RHODE ISLAND DEPARTMENT OF TRANSPORTATION

Pine Street Bridge No. 548 (31)

NOTICE TO PROSPECTIVE BIDDERS

ADDENDUM NO. 2 Prospective bidders and all concerned are hereby notified of the following changes in the Plans, Specifications, Proposal and Distribution of Quantities for this contract. These changes shall be incorporated in the Plans, Specifications, Proposal and Distribution of Quantities, and shall become an integral part of the Contract Documents.

MEDIAN BARRIER DETAIL
STA. 171+85 TO STA. 172+65
NOT TO SCALE

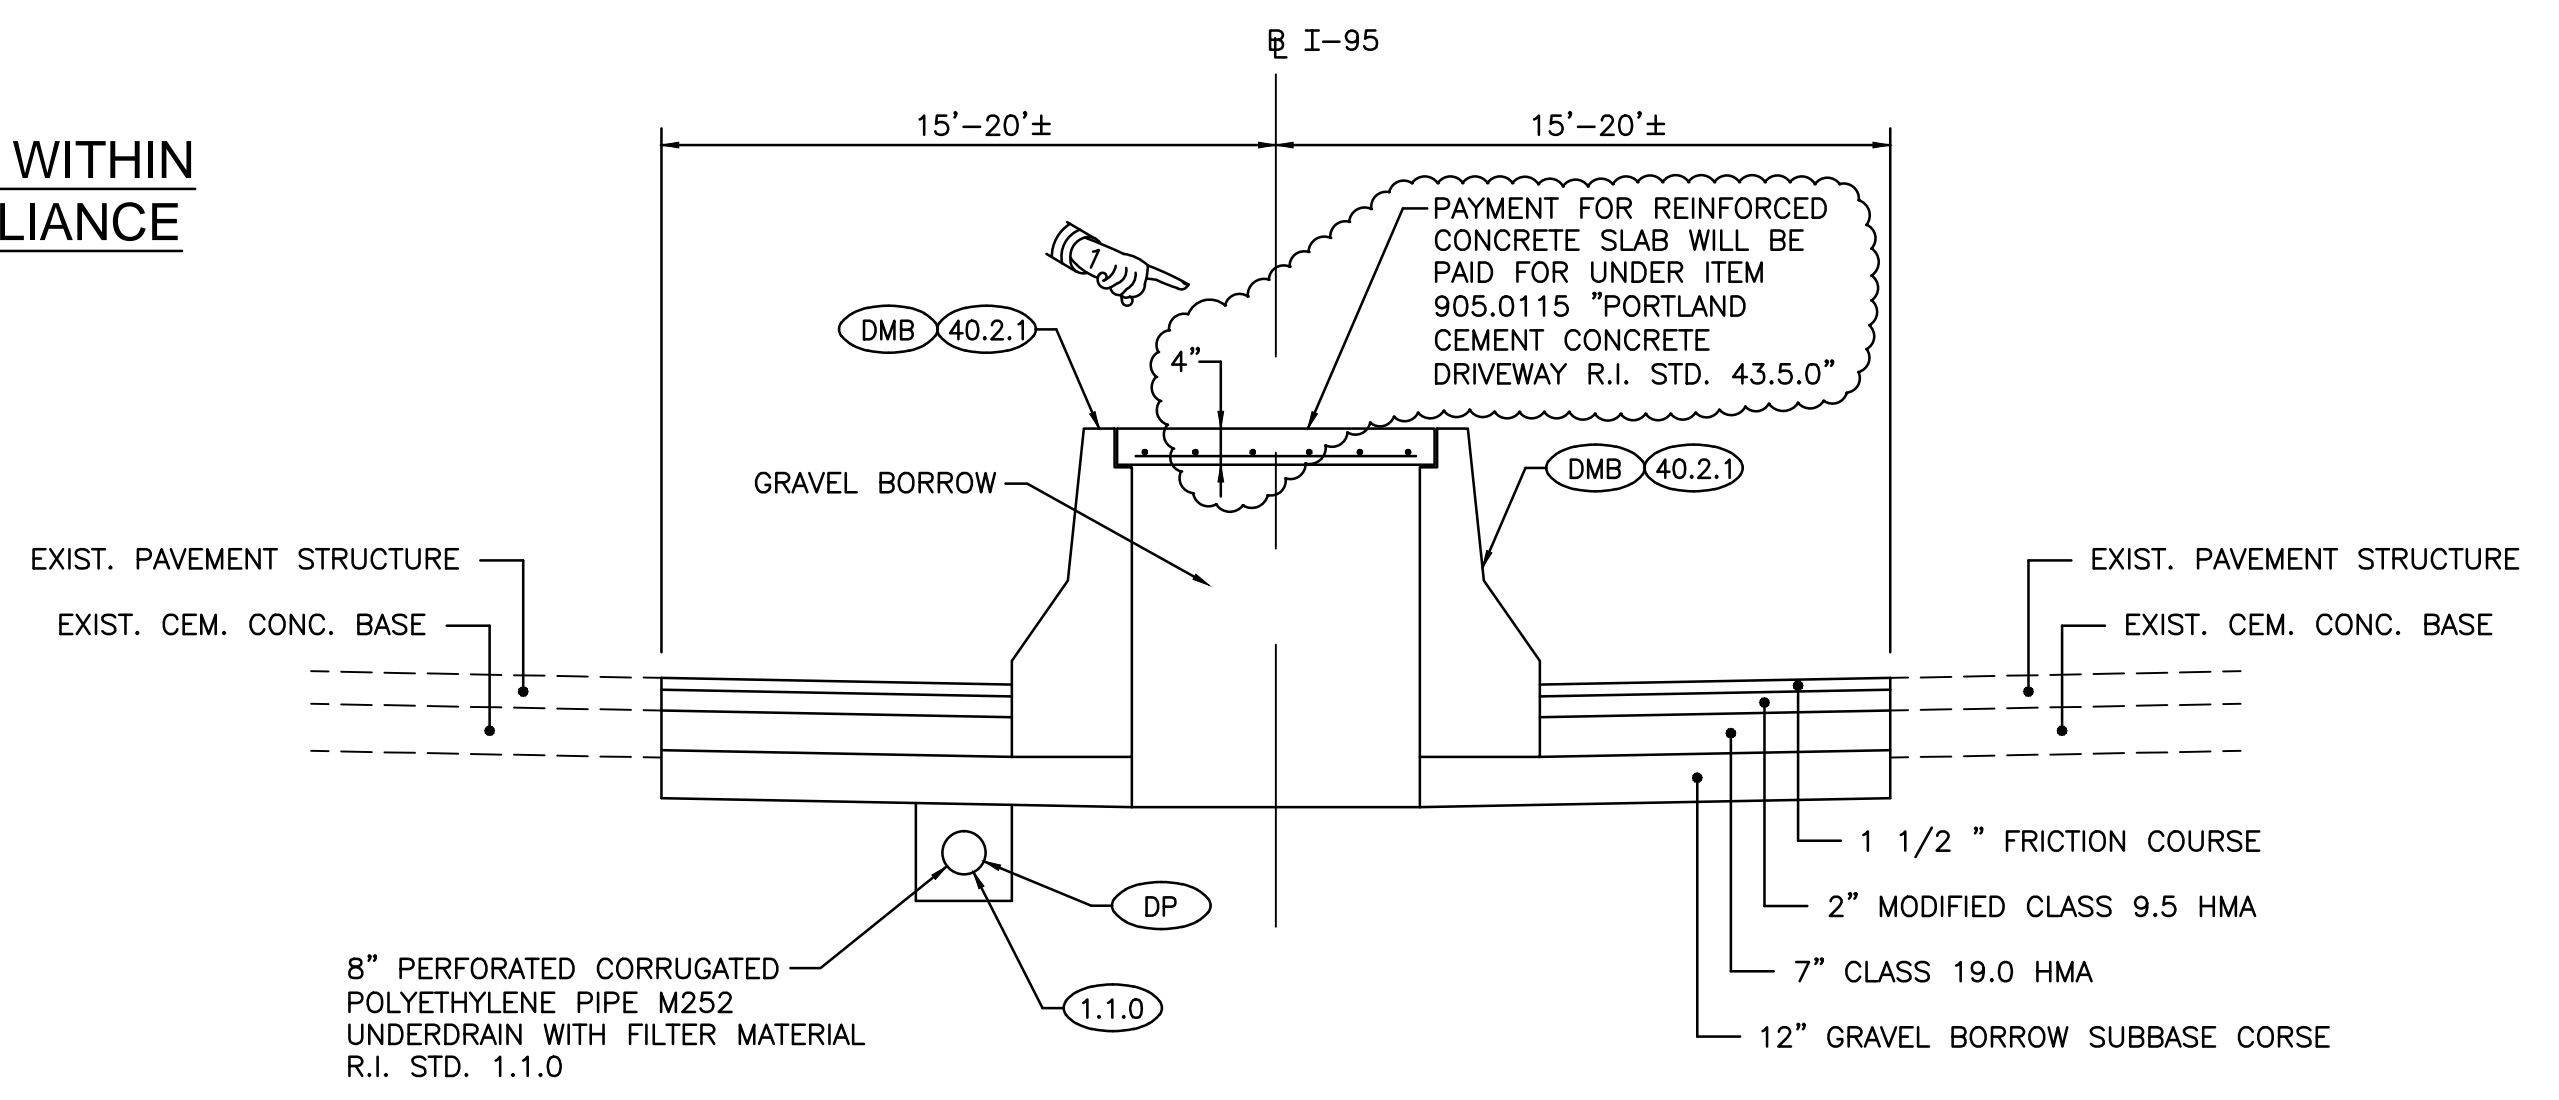
Delete Sheet No. 38 in its entirety and replace it with revised Sheet No. 38(R-1) attached to this Addendum No. 2. The Median Barrier Detail has been revised and Note 3 has been added to the General Notes.

2. Sheet No. 40 - General Plan - 1 Pine Street

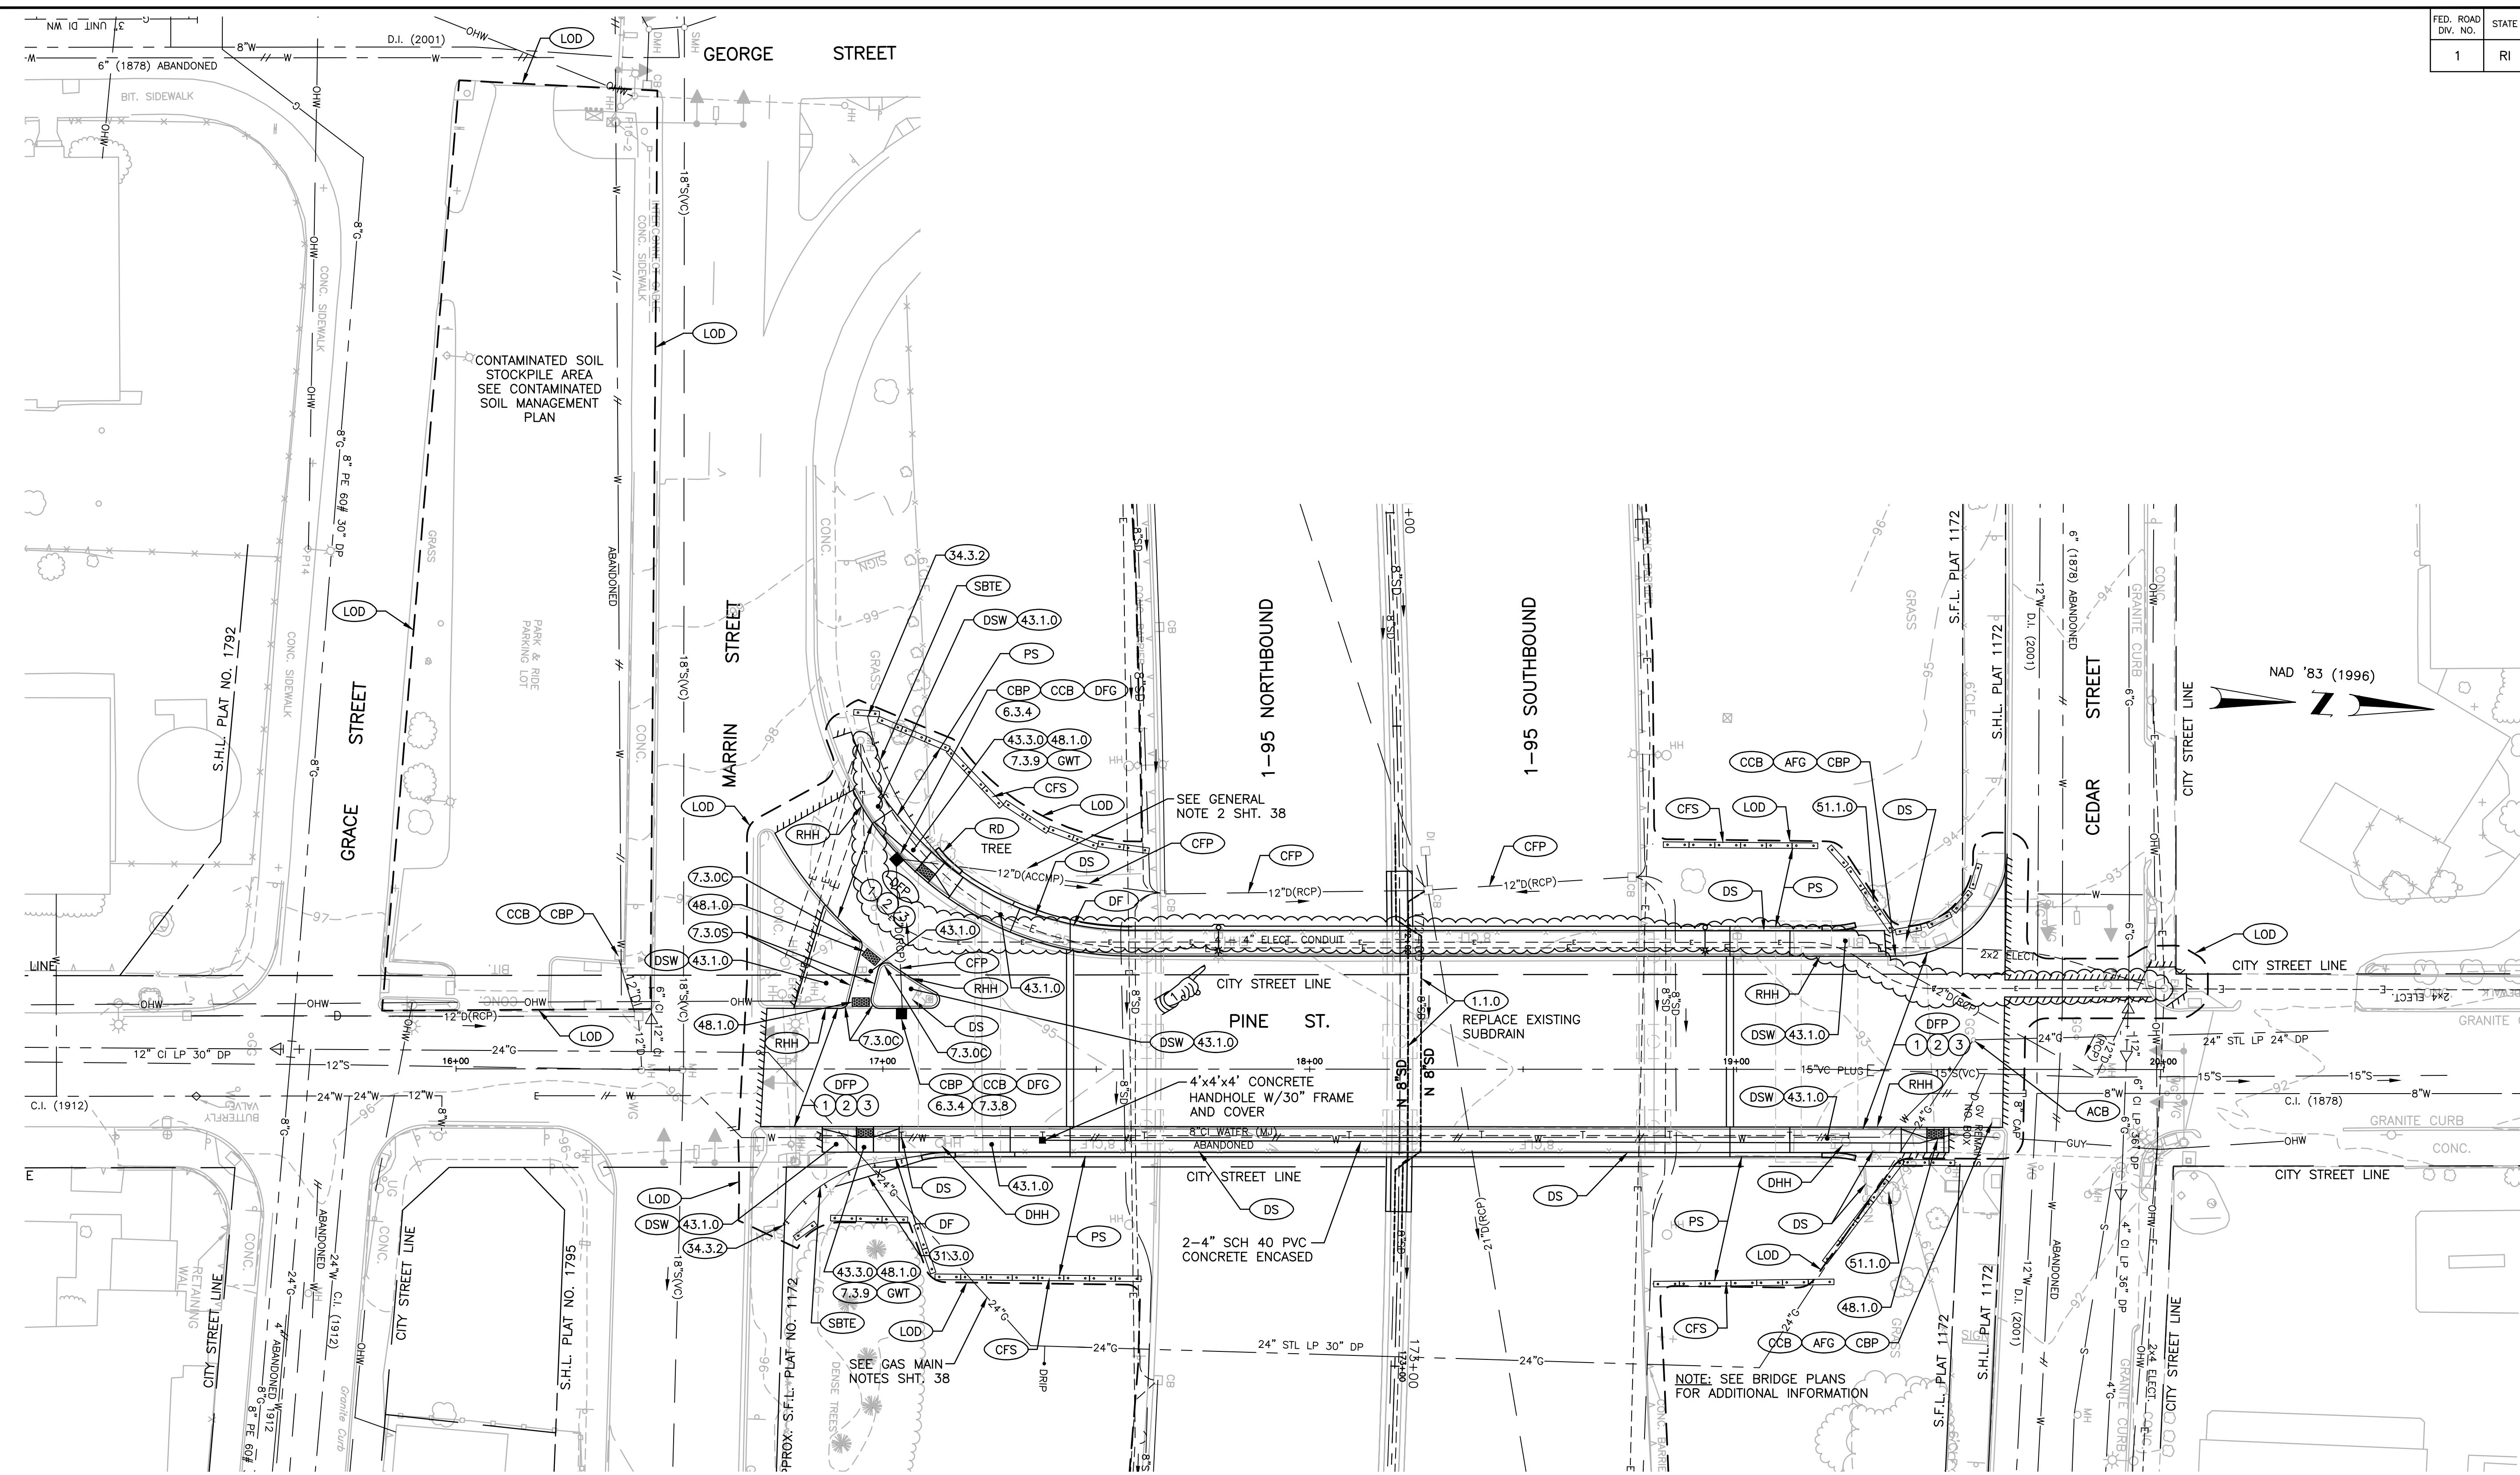
Delete Sheet No. 40 in its entirety and replace with revised Sheet No. 40(R-1) attached to this Addendum No. 2. The size and layout of the electric conduit has been revised.

**GENERAL PLAN - 2
ROUTE 95**

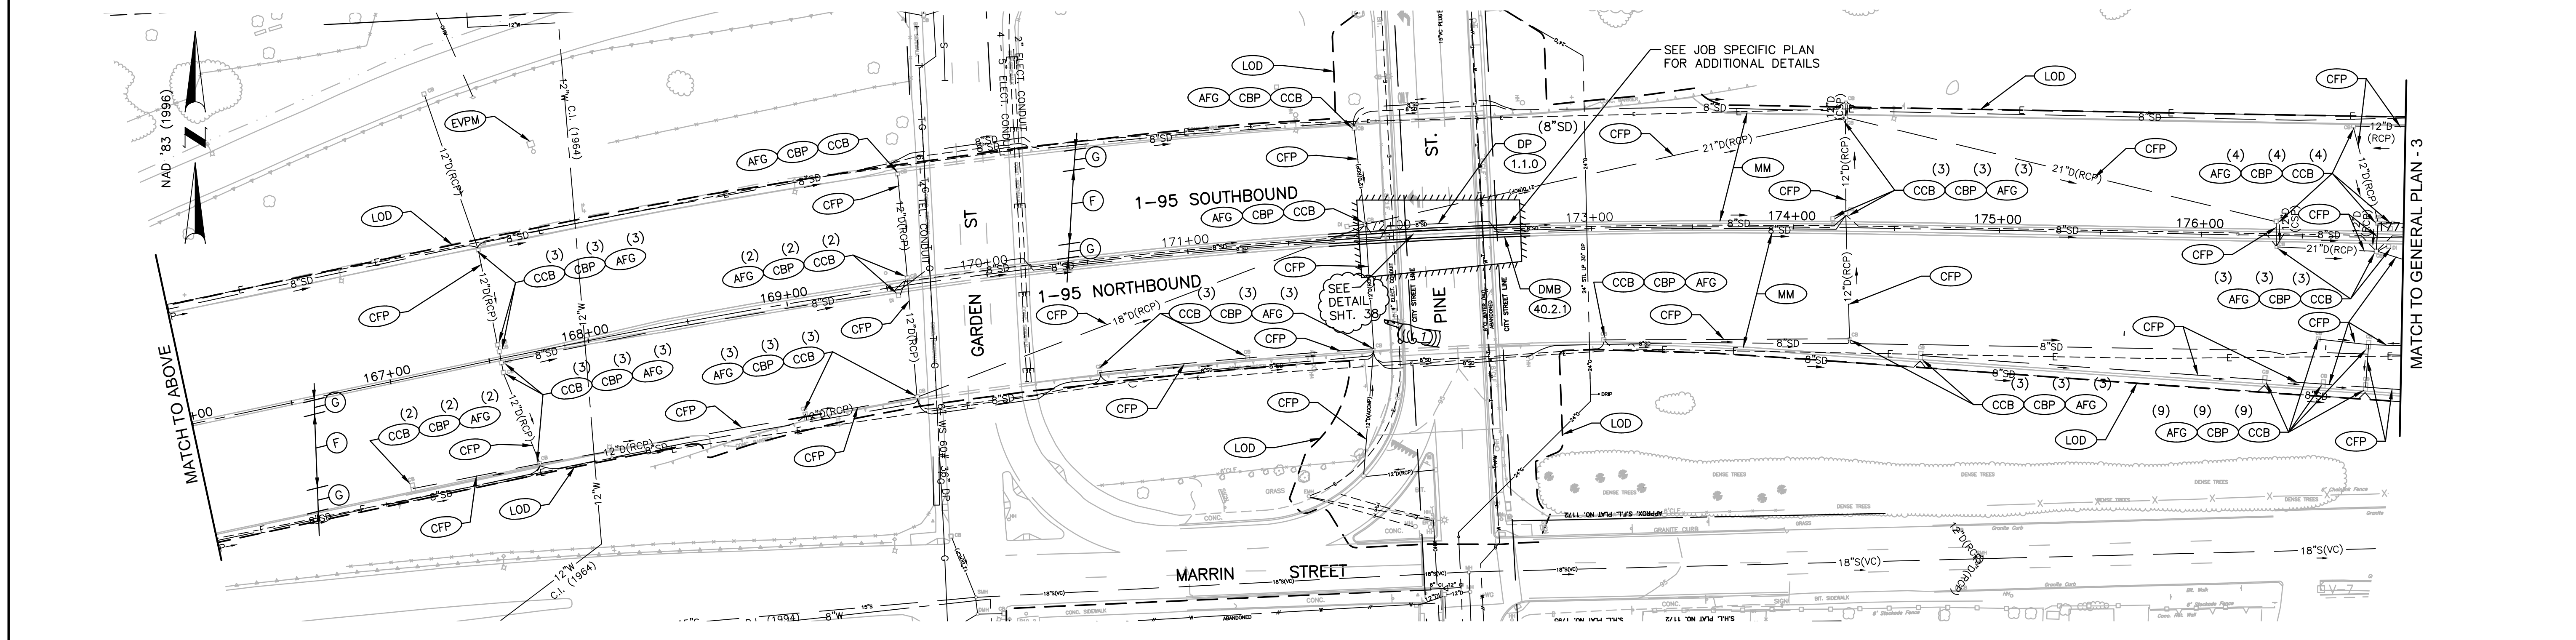
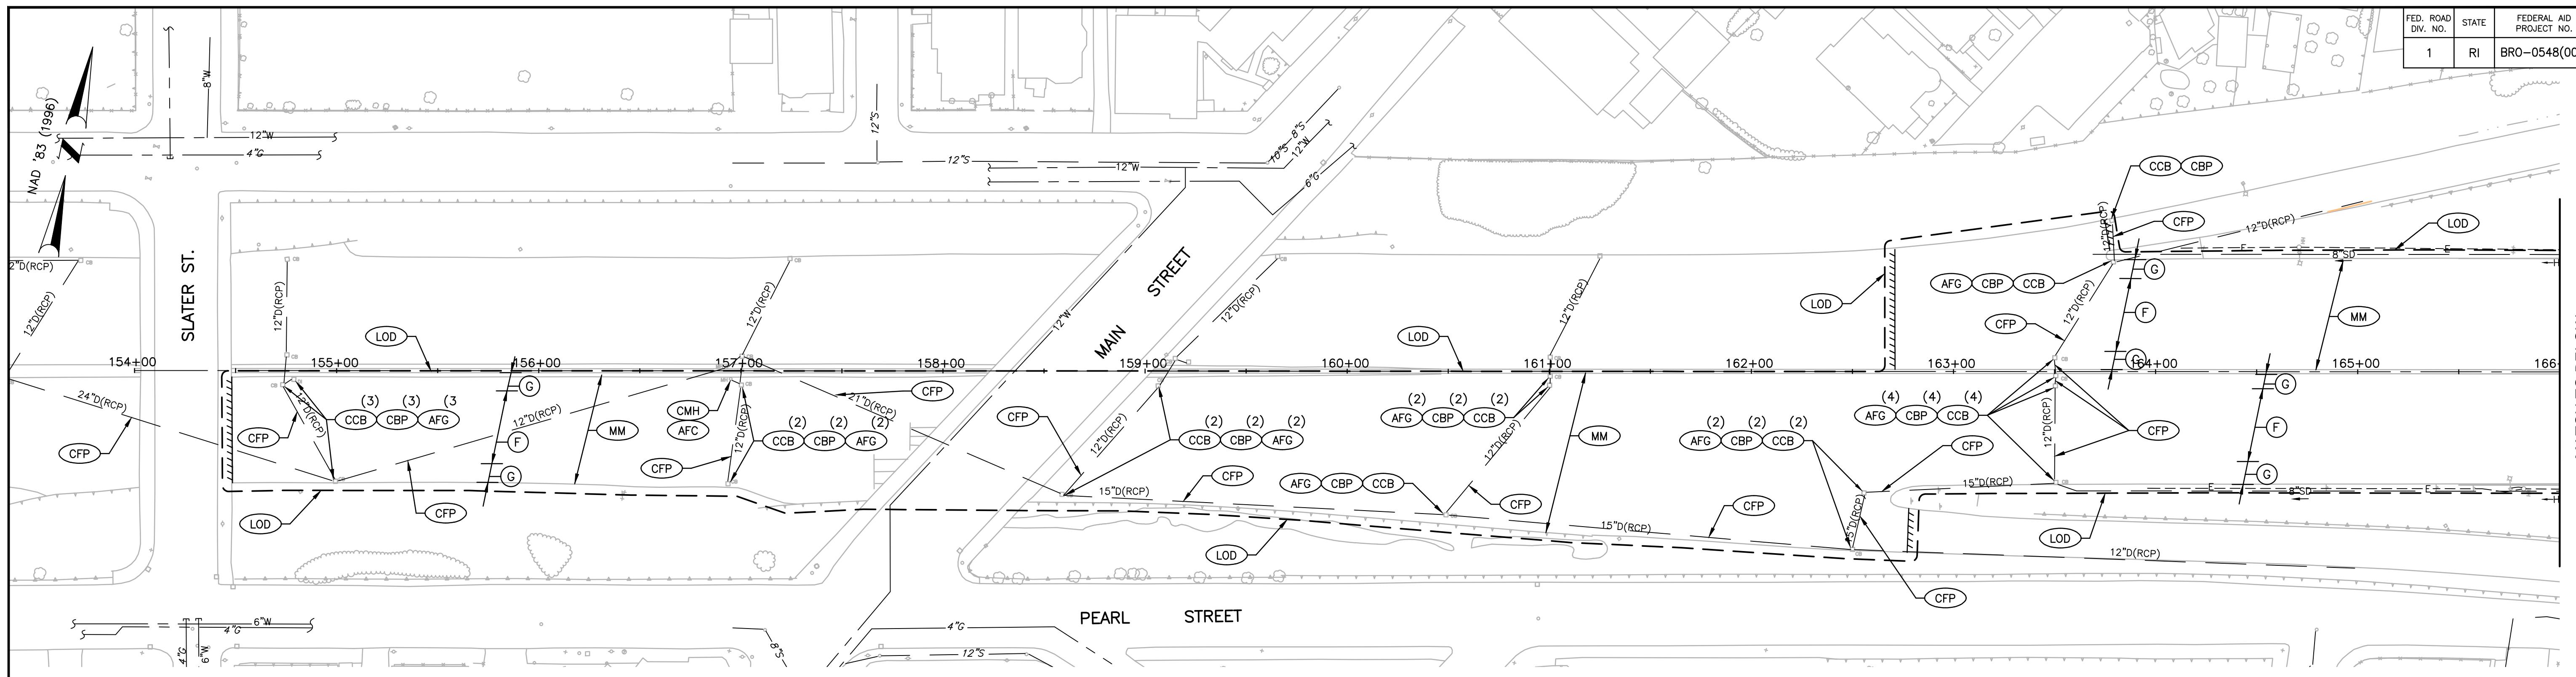
Delete Sheet No. 41 in its entirety and replace it with revised Sheet No. 41(R-1) attached to this Addendum No. 2. The RI Std. 43.5.0 callout at the median barrier has been revised.
